**NSLPP MEETING HELD ON 07/08/2024****Attachments:**

ADDRESS: 10 Colin Street, Cammeray**APPLICATION NO:** DA311/23**PROPOSAL:** Alterations and additions to a detached dwelling and a secondary dwelling including demolition, construction of a first floor addition, a garage building and a swimming pool**PLANS REF:**

OWNER: Alexandra Margaret van Schalkwyk**APPLICANT:** Ken Demlakian**AUTHOR:** Report of Robin Tse, Senior Assessment Officer**DATE OF REPORT:** 22 July 2024**DATE LODGED:** 27 October 2023**DATE AMENDED:** 25 March 2024**RECOMMENDATION:** Deferred Commencement

DATE	REVISION
DRAWING PROPOSED LANDSCAPE PLAN	
ADDRESS	PROJECT #
10 COLIN STREET, CAMMERAY	
CLIENT	DATE #
Wiehahn & Ally van Schalkwyk	14/09/23
	DWG #
	L/01
DRAWN	
DY.S	
CHKD	REVISION
JC

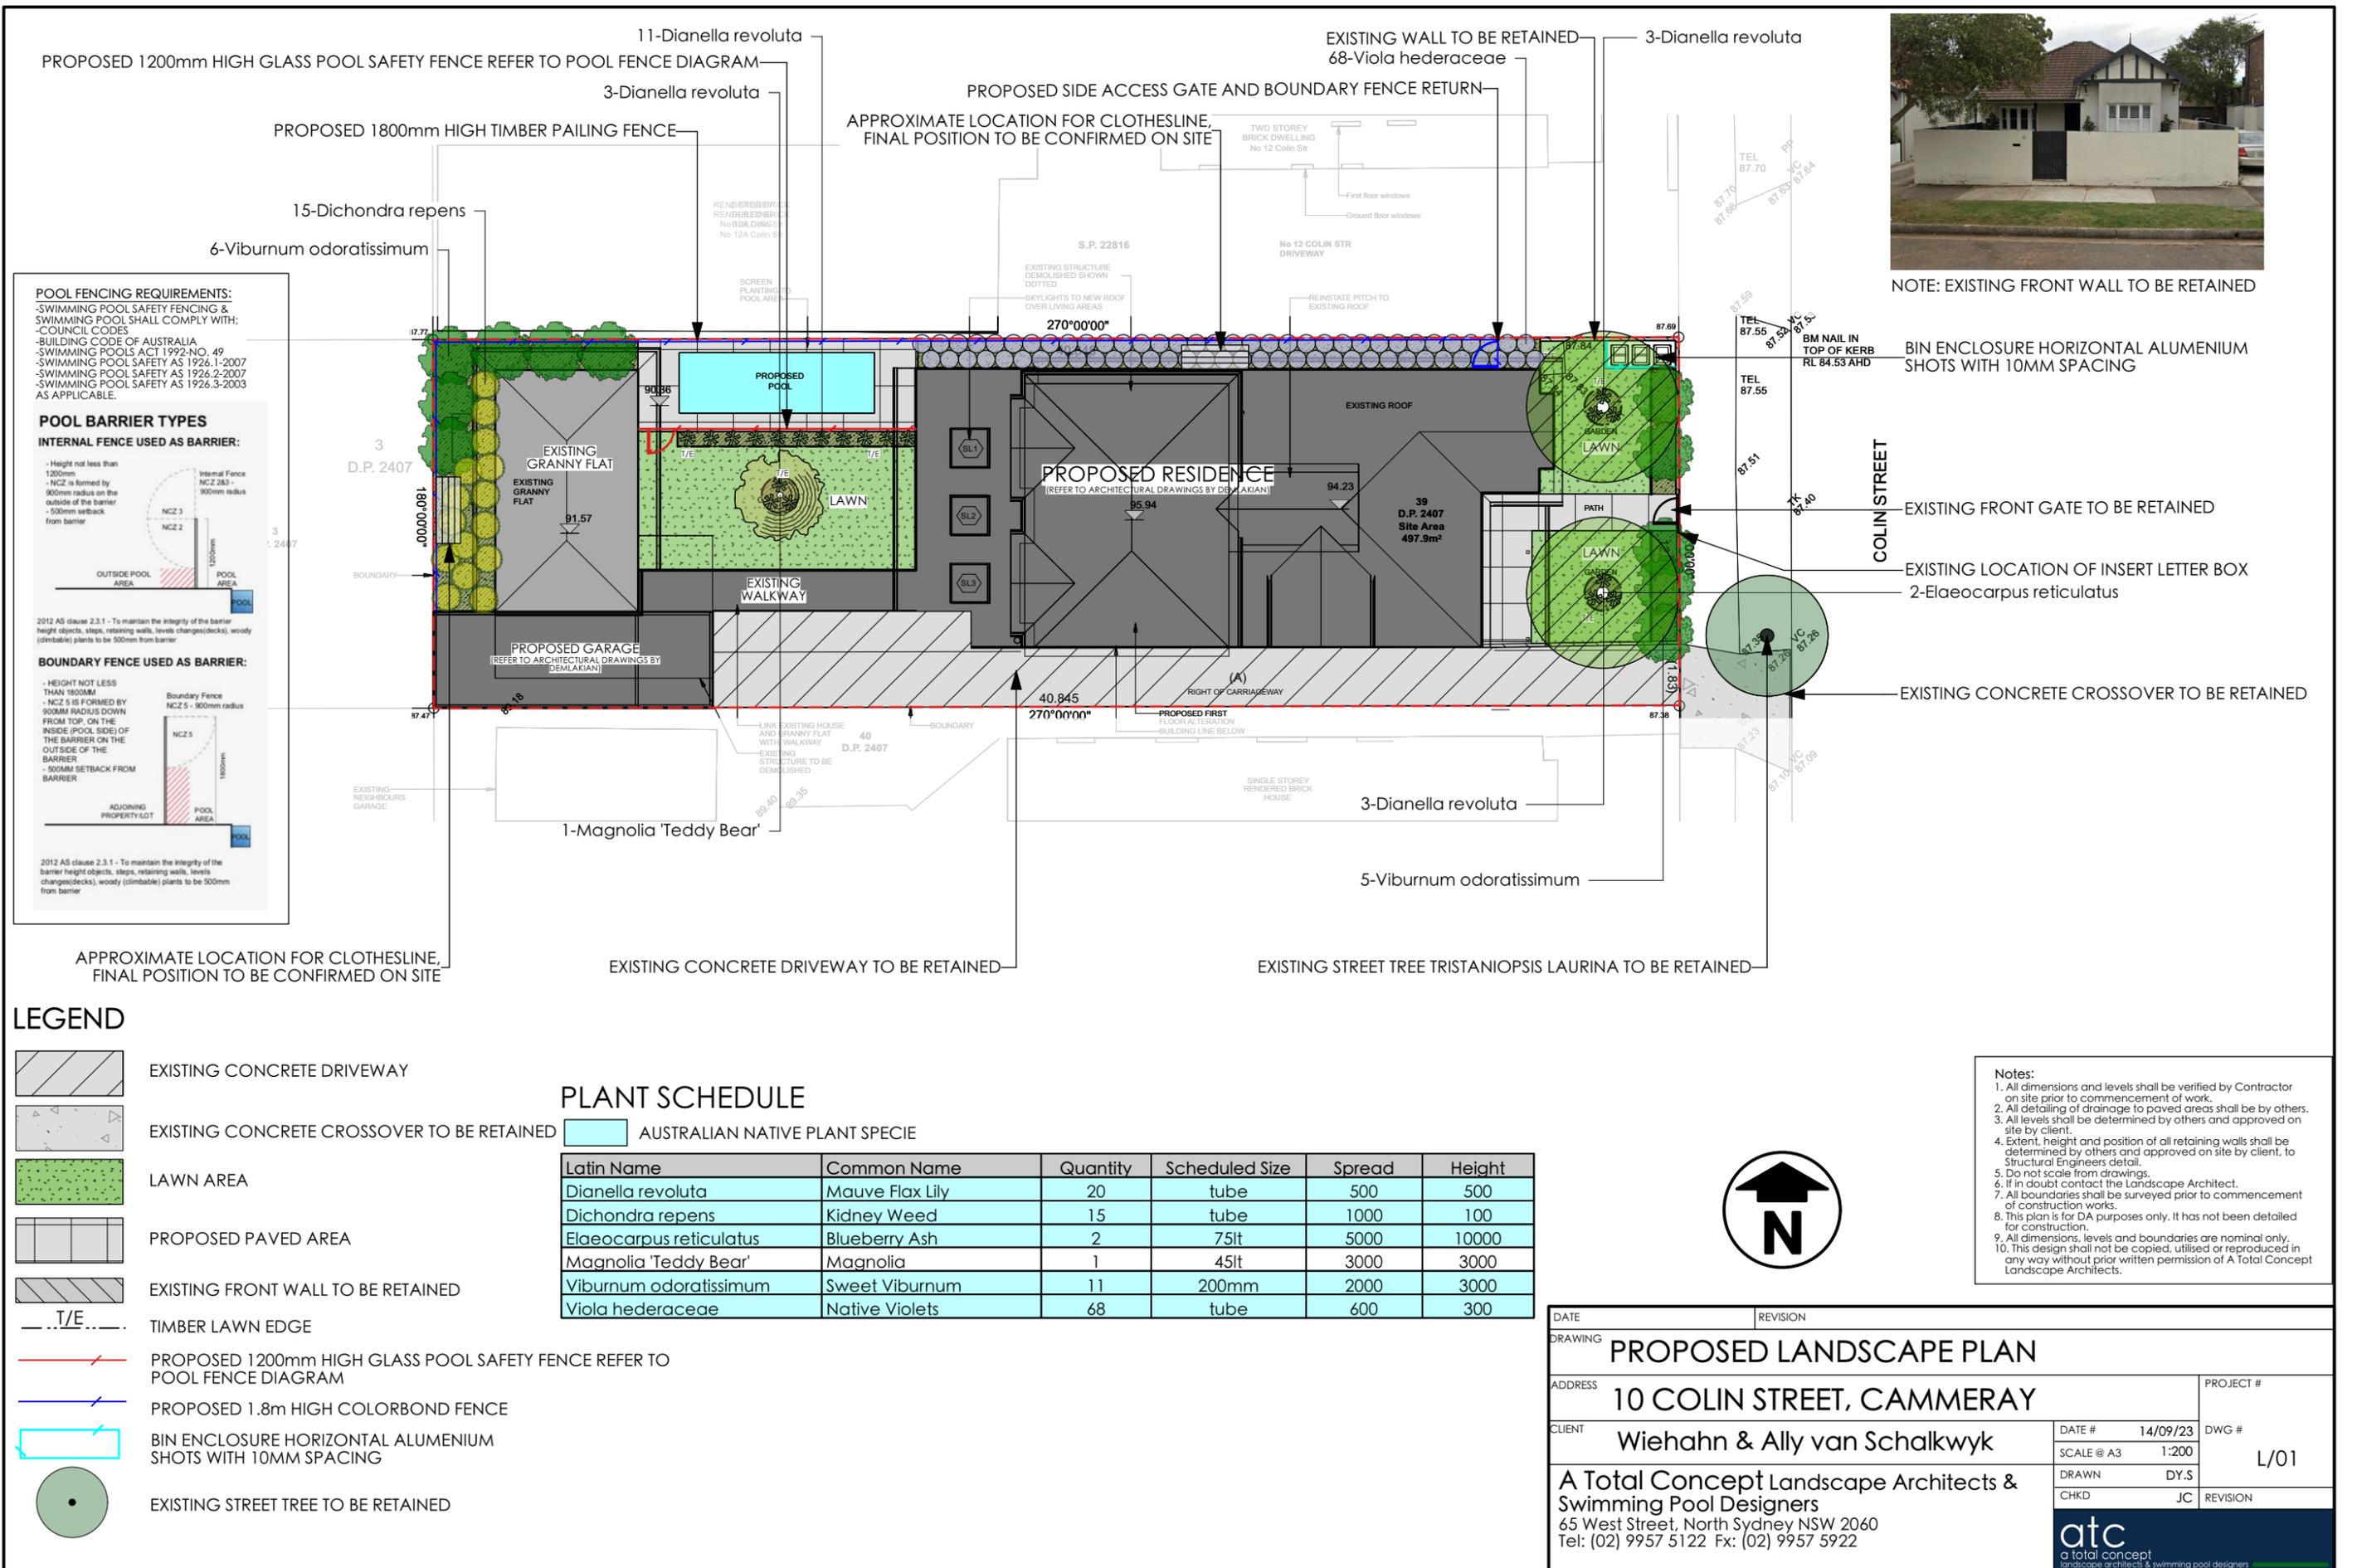
- (c) The *Viburnum odoratissimum* (200mm) shown to be planted along the narrow northern rear boundary adjacent to the secondary dwelling shall be replaced with a species (300mm) better suited to this narrow space in dry shade beneath the eaves of the dwelling (Note: Consideration shall also be given to maintenance requirements/access when considering plant choice);
- (d) Pot size of all *Viburnum odoratissimum* shall be increased from 200mm to 300mm;
- (e) 1 x *Tristaniopsis laurina* 'Luscious' (100lt) shall be planted in the council verge (northern end) in front of 10 Colin Street.

C2. The applicant must submit a revised landscape plan, based on the submitted landscape plan (Drawing numbered L01 prepared by A total Concept and dated 14 September 2023) incorporating the following:

- (a) Soft landscaping shall be provided on the areas affected by the deletion of the enclosed passageway and the provision of a 900mm setback for the proposed garage building from the rear (western) property boundary as required by Condition AA2;
- (b) The 1 x *Magnolia* 'Teddy Bear' (45lt) shown to be planted in the centre of the rear setback shall be replaced with a more upright small to medium tree (75lt) with a vase-shaped open canopy (eg *Lagerstroemia indica*) capable of achieving a mature height of 7m min planted towards one of the southern corners of the rear setback;
